RE: No. LBC HGY/2024/0074

Project address: 42 Southwood Lane, London, N6 5EB

Discharge of Condition 03

Further to the submission of documentation for the discharge of condition 03 submitted on 10.01.2024 by Retrouvius Design and subsequent Heritage Report by The Heritage Practice submitted in April 2024, a response was emailed on 30th April 2024 to request some further clarifications and details. This document addresses each of these points.

Above: Current photos of balcony to rear first floor room (to RHS when standing in the room).

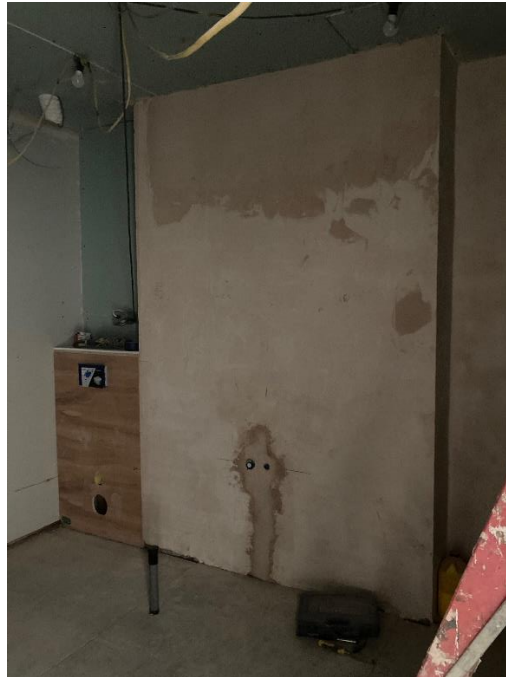
- Condition 3.2- works to balconies to rear elevation 3.2.15 & 3.2.16: No information provided. Please provide relevant information.

See additional detail added to 3.2.15 (Item 3.2.16 is incorporated so is no longer a separate item).

- The existing balcony railings have been checked and are in relatively good condition.
- Maintenance works have been carried out as follows:

- Remove existing paint, rust, and debris from the iron balcony using by wire brushing.

- The railings have been repainted with black Hammarite metal paint.

No further works to the railings are proposed.

The base of the balcony have had moss/ vegetable matter removed and have been rubbed down and had loose paint removed in preparation for redecoration. These and the existing render to rear elevation of the house will follow the approach under 3.1.3 – 3.1.12 above to carryout maintenance work to make good and prepare for redecoration.

See photos of railings at the end of this document.
